PLANNING SERVICES APPLICATION

APPLICATION NO: PP/00/02809

SITE: 16 Holland Park, London, W11 3TH

PROPOSAL: Repair and redecoration. Erection of entrance canopy. Internal minor alterations. Mechanical and electrical works.

16 Holland Park, London W14 3TH
 for A Dantala
 Drawing 21 Diagram of proposed Conventional Fire Detection & Alarm Installation
 (facing page: Section 4 of Chubb Electronic Security Ltd.

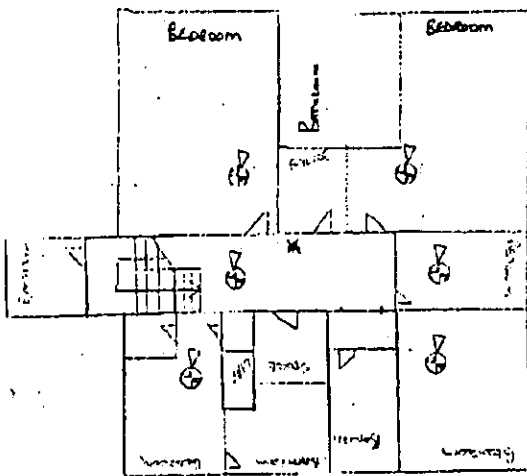
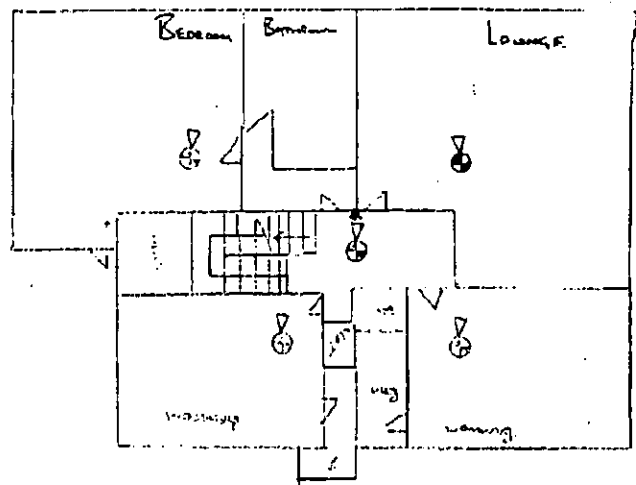
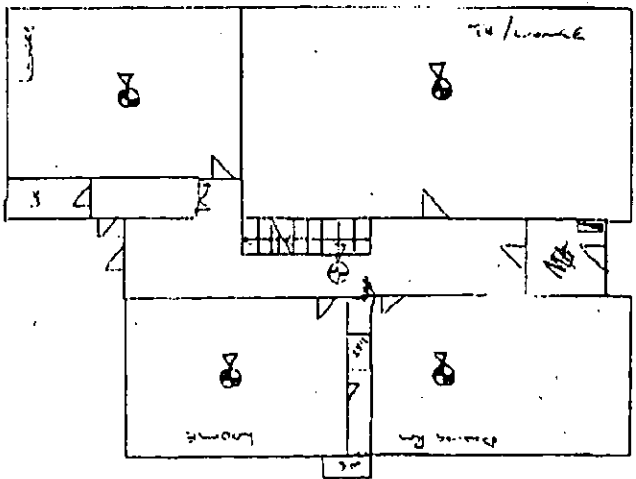
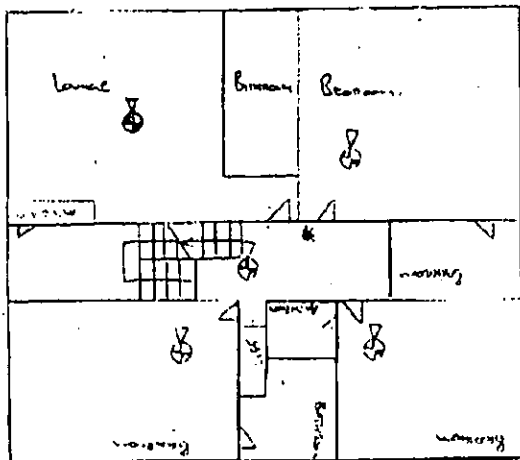
The house is a Large House defined by paragraph 1.5 of Approved Document B1. The works protect the escape route by installing a fire detection and alarm system described by drawing no.21 and Chubb's specification on the facing page. This system complies with BS 5839: Part 6: 1995 Grade B L3 (required by paragraph 1.7 of Approved Document B1) instead of Part 1: 1988 L2 (required by paragraph 1.6) because BS 5839: Part 6: 1995 Grade B L3 is specific to dwellings. This L3 standard does not require manual call points or high powered alarms, and detectors are only in the escape route and high risk rooms (i.e. bedrooms) because occupants can be assumed to be familiar with the building.

Extend fire detection to lower risk areas of living rooms and store rooms and provide manual call points on each landing. Please find enclosed drawing 21 rev A amended accordingly. If this is acceptable Chubb will amend and reissue their quotation and specification for your files.

Substitute a system compliant with BS 5839: Part 6: 1995 Grade B L3 required by paragraph 1.7 of Approved Document B1 to provide the above and also increase audibility of the alarm. If this is acceptable Chubb will amend and reissue their quotation and specification for your files.
